Campus reconstruction brief

Ten circled game targets compared with their real street-view references

Pair 2 | GCB Bank near Ernest Chemist with mall behind

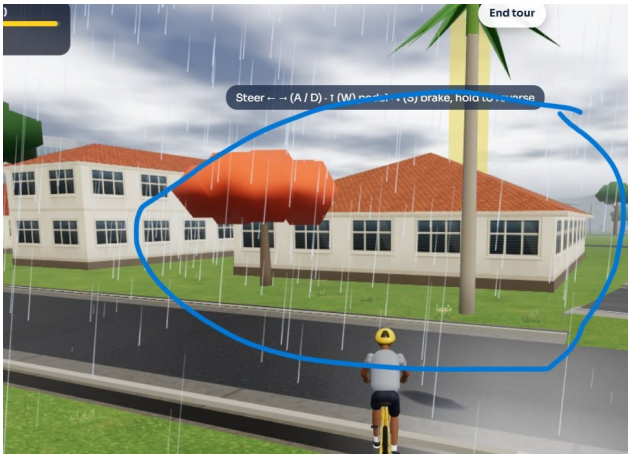
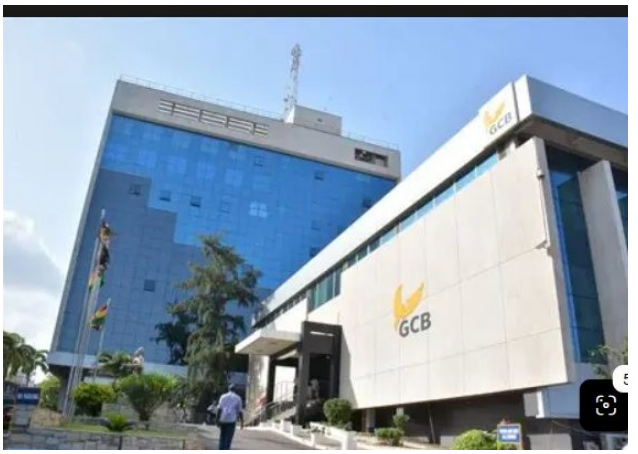
The circled low game block is another view of the very same GCB building in Pair 1. The white-clad bank face with GCB signs, a tall dark glazed recess, canopy and entrance ramp occupies the right foreground. The tall blue reflective storey building at left rear is Legon City Mall, seen behind the bank because of the photograph's angle. The game instead uses generic repeated windows and orange roof tiles and loses this foreground/background relationship.

Geometry and construction stage. Use the shared GCB Bank near Ernest Chemist and Legon Police Station asset and footprint from Pair 1. Rebuild the bank's visible return and this white panel-clad elevation, strong rectangular frame, deep vertical blue-glass recess, projecting entrance canopy, stairs, ramp and roof-edge GCB sign. Put the tall blue-glass mass on the separate Legon City Mall footprint behind it; coordinate its skyline with Pair 4. Never label, attach or model the mall tower as an upper storey of the bank or as the GCB classroom building. Match the visible overlap and perspective before changing either building's scale.

Ground and environment. Rework the bank frontage as paved access with planted islands, low shrubs and realistic trees instead of a continuous green carpet. Place the visible flags on slender poles near the approach. Use the roofline, mall-bank occlusion and camera angle as placement checks. Maintain an unobstructed entrance and accessible route.

Acceptance view. One low GCB building must work for Pairs 1 and 2, while the taller mall remains a separate structure behind it in this camera. The two silhouettes and their overlapping edges should align with the reference.

Pair 4 | GMI Motors frontage and Legon City Mall

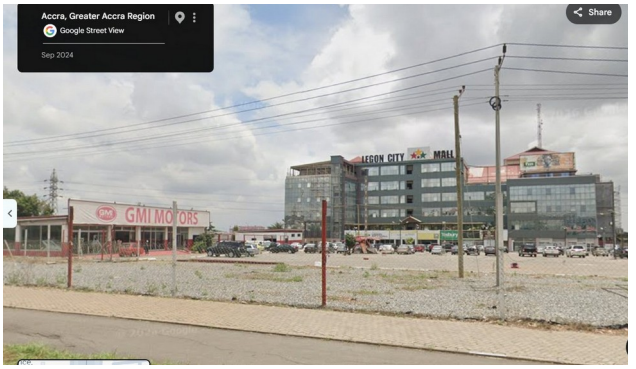
Two red circles select different errors. At left, the game makes the nearer commercial frontage a three-storey white tiled institutional block. At right, it renders Legon City Mall as an oversized, regular blue-glass box. The reference shows a low GMI Motors frontage to the left and a large, built mall behind and to the right, with grey solid masses, varied glazed bays, a stepped flat roofline and rooftop mall sign. The gravelly open foreground remains rough and sparsely occupied.

Geometry and construction stage. Treat the left showroom and right mall as separate assets at separate depths. Replace the classroom block with a low commercial building bearing the supported GMI Motors sign and large display openings. Rework the mall into the visible stepped rectangular masses, alternating light-grey panels and dark blue glass rather than an all-glass grid. Position and scale the rooftop LEGON CITY MALL sign by the reference silhouette. Keep the visible building complete while leaving the forecourt unfinished-looking.

Ground and environment. Build the pale gravel/soil parking area and a few optional cars. Add the foreground chain-link fence on red-brown posts, roadside paving, asphalt, poles, wires and mature roadside trees. Ensure the fence does not become a solid masonry wall and that the mall sits behind the near frontage.

Acceptance view. Both red-circled structures should be recognizable at once, with the low GMI building in front, the larger varied mall behind, and an open gravel foreground rather than a landscaped campus lawn.

Pair 5 | Roadside strip in front of GCB Bank

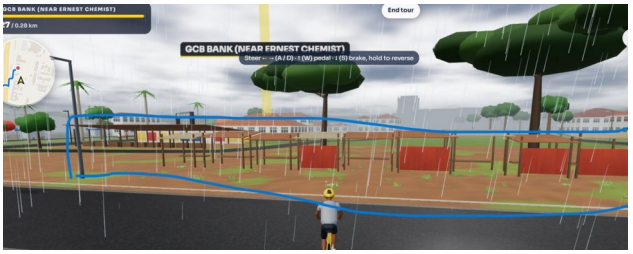
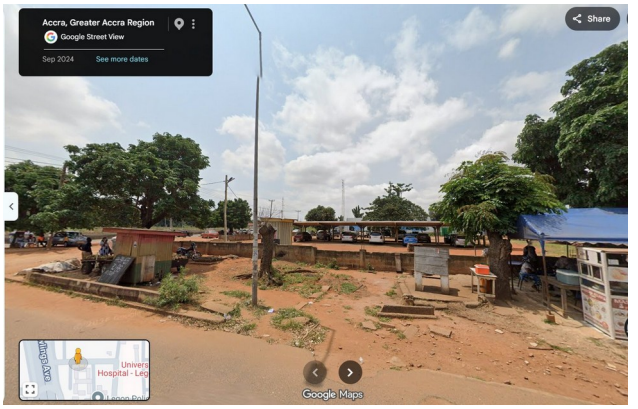
The blue-outlined game strip is a neat continuous framework with repeated upright poles and colored panels over a clean surface. The reference is less regular: reddish compacted earth, a small shed or kiosk, low masonry partitions, broken pavers and an open edge with vegetation. A long thin-roofed vehicle shelter and parked cars stand behind this informal foreground, while a blue tarp canopy appears at the right.

Geometry and construction stage. Place this strip in front of GCB Bank near Ernest Chemist and Legon Police Station, beside the road. Separate the small foreground kiosk, partition walls and rear parking shelter into different meshes. Give the shelter a shallow metal sheet roof on slender supports at the actual setback, without turning it into an uninterrupted street-market facade. Model only the visible incomplete or makeshift edges; avoid inventing a continuous finished shop row. A blue tarp and simple stall structure may be modular props at the right.

Ground and environment. Replace smooth ground with red earth, patchy grass, stones, open drainage or gaps where visible and a rough transition to the asphalt road. Place the large left tree, overhead shade, a simple pole and sporadic plants. Keep the parking cars movable and preserve usable clearances along the roadside.

Acceptance view. The front-of-GCB roadside scene should show rough small structures in front of a light vehicle canopy. Repeated painted panels must no longer dominate the view. Pair 6 is across this road.

Pair 6 | Roadside stalls against Legon Police Station wall

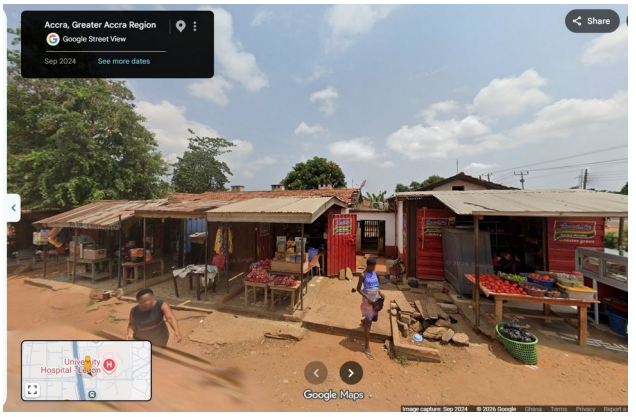
The game replaces the real informal roadside market line with three complete, equally spaced white-and-red houses, matching hip roofs, regular windows and tidy lawn. The reference has small kiosks and open stalls of different heights and widths. Timber and painted metal fronts sit beneath weathered corrugated metal roofs; some produce is set on simple tables. A white connecting wall and gate appear farther back.

Geometry and construction stage. Position these stalls directly opposite Pair 5, attached along the side walls of Legon Police Station. Remove the cloned house templates. Make each supported kiosk a simple separate structure with low roof pitch, sheet-metal or timber cladding, open front, irregular fascia and modest awning. Use restrained readable signage only where the photograph supports it. Preserve the police station's connecting masonry wall and any distinct rear roof rather than treating all visible shapes as one building. Allow openings and gaps between shops.

Ground and environment. Rebuild the raised rough thresholds, broken steps, compacted reddish earth, stones, patchy weeds and hard roadside edge. Mature branches and power lines cross the scene. Small produce tables and goods can be optional props, positioned to avoid obstructing the playable route. Keep material wear local: rust, dirt and faded paint should vary.

Acceptance view. At bicycle height, the road between the GCB frontage and the police station wall should pass a varied low row of corrugated kiosks, with earthy ground and open fronts; no identical completed houses should remain.

Pair 7 | West side of Legon Main Gate

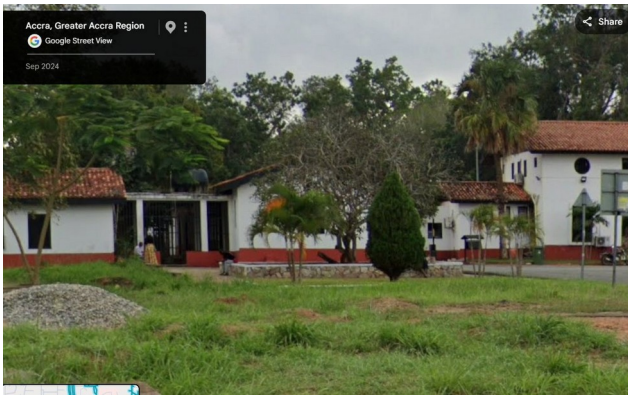
The circle targets the generic three-storey game block in the center. The reference centers on a low white gate or service frontage with a red-brown base, weathered red-tile roof and dark recessed grille or colonnade at the passage. At right, a separate, genuinely taller two-storey gable-ended block has a circular high opening and glass notice boards. The game's uniform storeys and window grid erase this height variation.

Geometry and construction stage. Place the view at the west side of Legon Main Gate when approaching from the front of Legon Police Station. Replace the circled central mass with the lower gatehouse and its correct roof profile, piers and deep dark portal. Keep the taller right block as a distinct mass with the circular high vent or window and framed notice displays. Match the join and roof heights from shared edges; do not lower the real two-storey volume when correcting the central placeholder. Use bars and deep recesses only where visible.

Ground and environment. Add the mature broad-canopy trees and palms, shaded uneven grass, low stone-edged planted bed, conical shrub, roadside earth and small gravel patches. The landscaping should have worn transitions instead of uniform green. Check clearance through the gate or path and align it with the nearby circulation.

Acceptance view. The finished comparison should have a clearly low middle frontage beside the separate two-storey gable at right, with a deep shaded opening and densely planted surroundings.

Pair 8 | JQB front parking court and unfinished frame

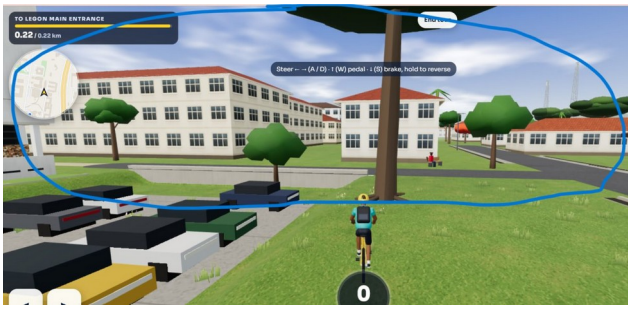
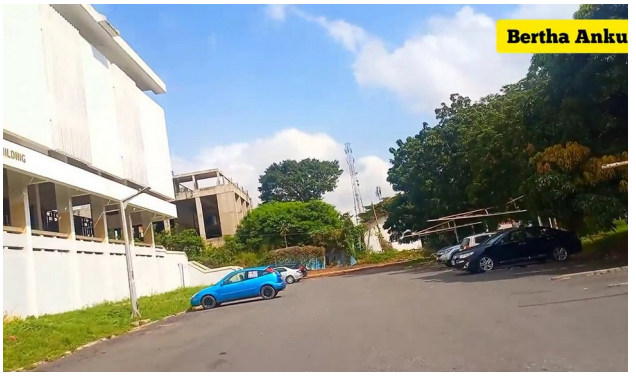
The large blue circle includes several orderly, completed white campus blocks in the game. In the reference the prominent left building is completed, but the central multi-storey structure is an unfinished grey concrete frame: exposed columns, slabs, beams and open upper bays, without installed facade, windows or finished roof. A thin metal carport shelters cars on the right. Treating every footprint as a finished white block misses the key state of the site.

Geometry and construction stage. Place this scene at the front side of the JQB building. Retain or rebuild the completed left-hand JQB mass separately, including its deep eaves, broad blank wall and visible open ground-level bays. Replace the central generic finished block with an exposed structural grid at the photographed number of visible levels. Show open air through its bays and bare slab edges; keep its roof frame open. Avoid adding glass, plaster, completed railings or a decorative roof not in evidence. Model the right carport with thin posts and a shallow sheet roof. Pair 10's target building is across the road from this unfinished structure.

Ground and environment. Rework the asphalt parking court with subtle local grade and curb transitions, planted edges, mature trees, parked cars and distant telecom masts as alignment cues. Make cars optional props. Confirm whether the slope is perceptible through matched cameras before setting its exact elevation. Collision should follow the asphalt and avoid stray obstacles on the rideable path.

Acceptance view. A clean render must make the completed left building, unfinished central frame and lightweight right carport visibly different construction types.

Pair 9 | Overhead crossing in front of Legon Main Gate

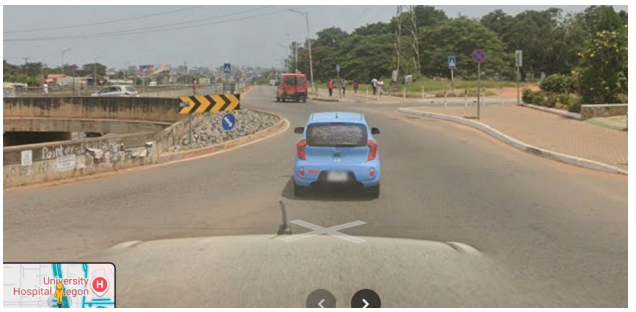
The circled game target is the overhead crossing in front of Legon Main Gate. In this real viewpoint, the traveled upper road curves right beside a low stone-filled triangular splitter island with black-and-yellow chevrons and a blue keep-right sign. The lower opening beneath the overhead structure is visible at left. A second game/real comparison and the user-annotated top view clarify the length of its approaches: the purple-arrow side in the game is already about right, while the yellow-arrow side ends too soon. The longer blue arrow marks the approximate desired run to the main road.

Geometry and construction stage. Reconcile both road levels and their connections before changing meshes. Keep the purple-arrow side at its present approximate extent. Extend the short yellow-arrow underpass approach approximately along the blue-arrow alignment to its downstream main-road merge; reposition its retaining wall, parapet, roadway and grade transitions together. Preserve the overhead deck and lower opening; do not flatten or delete the grade separation. Shape the photographed upper traveled approach as a rightward curve around the triangular stone island, with its raised pedestrian sidewalk. Check the extension from the game map and both ground-level viewpoints rather than scaling the entire underpass uniformly.

Ground and environment. Add trees along the far verge, local signposts and utility details where visible. Match slight changes in grade from surface and curb evidence, not a guessed surveyed slope. Cars, bus and people are optional moving references. Give the curb, stone island and bridge edge suitable simple collision; do not drive the bicycle through the island.

Acceptance view. From the reference camera the rightward curve and triangular divider should dominate, while the genuine lower passage remains visible at left. In plan, the purple extent stays, and the yellow side reaches the approximate blue-arrow endpoint before merging smoothly into the main road.

Pair 10 | Office across road from unfinished JQB building

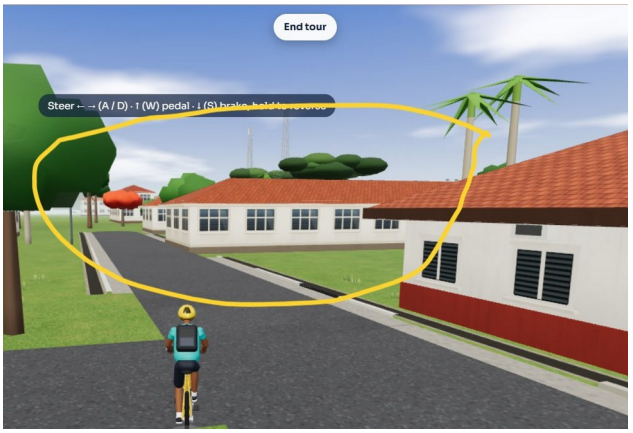
The circled game frontage repeats neat completed white-and-red one-storey blocks with bright orange hip roofs and identical windows along a straight lane. The reference has a particular low, long office building with an aged dark grey-brown tiled gable roof, red lower wall, varied barred or recessed openings and an AC unit. A large freestanding sign reads UNIVERSITY OF GHANA / FINANCE DIRECTORATE / STUDENTS ACCOUNTS OFFICE. A broad mature tree and tall grass strongly shape the view.

Geometry and construction stage. Place this circled target in front of JQB, across the road from Pair 8's unfinished building. Replace the cloned row with the visible long single-storey mass and its actual roof pitch, eaves and wall-bay rhythm. Place the dark barred openings, door recesses, red plinth and AC condenser according to the photograph. Put the main sign on two posts at the observed foreground position; reproduce the large legible wording exactly and leave small unreadable lines unresolved. Keep any separate neighboring wing distinct. Include the corroded rectangular gate frame at the left if it remains within the comparison angle.

Ground and environment. Use long uneven grass, a compacted or paved approach gently rising to the right, soil at the tree base and heavy dappled shade. Blend building threshold, route and vegetation naturally. The tree should have a wide realistic canopy rather than a small geometric crown. Do not line the entire lane with identical bright roofs.

Acceptance view. The sign, broad tree, aged dark roof and varied low office facade should anchor the matched view, with the approach and grass occupying the same visual proportions.

Overhead crossing | approach length and levels

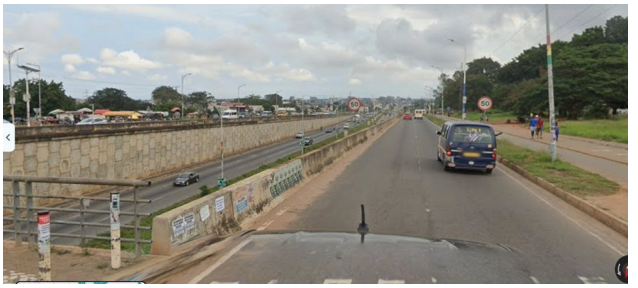
Purple arrow: the existing approach length is approximately correct; preserve its extent.

Yellow arrow: the game ends the opposite underpass approach prematurely.

Blue arrow: extend that short side to approximately this endpoint, where the lower route meets the main road.

Keep the overhead crossing and the vertical separation between the upper road and the lower roadway. Extend the retaining wall, parapet, collision surface and grade transition coherently. The arrow is a placement guide, not a surveyed distance.
